UNITED STATES PATENT AND TRADEMARK OFFICE

APPLICATION NO.	FILING DATE	FIRST NAMED INVENTOR	ATTORNEY DOCKET NO.	CONFIRMATION NO.	
09/988,322	11/19/2001	Hiromasa Ishiwata	356202/00	8420	
75	90 08/28/2002				
McGinn & Gibb, PLLC			EXAM	EXAMINER	
Suite 200 8321 Old Courthouse Road			VY, HUNG T		
Vienna, VA 22182-3817			ART UNIT	PAPER NUMBER	
			2828		
			DATE MAILED: 08/28/2002

DETAILED ACTION

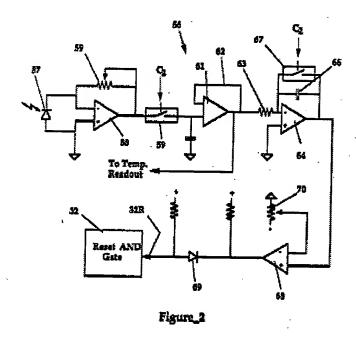
Claims 1-4, and 8-11 are rejected under 35 U. S. C. § 102 b as being anticipated by Rink, U.S. patent No. 4,950,268.

Regarding to claims 1,2,8 and 9, Rink disclosed in fig. 2 a control circuit for laser diode, comprising: an amplifier circuit (64) producing at an output terminal and feedback voltage that is indicative of an optical power via PD (57) generated by laser diode (not shown) in response to a driving current flowing there through; a driving circuit responding to output voltage to control driving current so as to make voltage difference small; a second amplifier circuit (61) producing at a second output terminal. (See Fig. below). It is inherent that amplifier circuit driving output terminal with a first time constant during a steady operation (created by two switch C2) and with second time second time constant because, when switch(67) is off (open) the gain the operation amplifier (66) is determined by the resistor (63) and capacitor (66), the RC operating to suppress overshoot and/or undershoot of the signal, thus amplifier (64) drives the terminal with a first time constant. When switch (67) is on (close) and switch (59) open then the operation of amplifier (64) functions as a voltage follower in spite of the resistor

(63) and capacitor (66). Thus, the amplifier 64 drives with a second time constant that is smaller the first time constant. (See Fig. below);

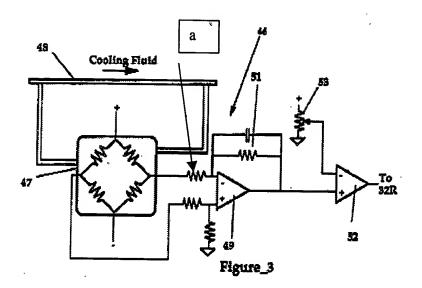
Regarding to claim 3, and 10 Rink discloses at least one of first and second amplifier circuit includes an operational amplifier (64 and 61), a capacitor (66) coupled between output and input ends of operation amplifier and first switch (67) coupled in parallel to capacitor (66) (See column 6, line 28 – 53 and Fig. below)

Regarding to claim 4, and 11, Rink discloses amplifier (49) circuit further a first resistor (a), a second resistor (51) coupled in parallel to capacitor (See fig. below).
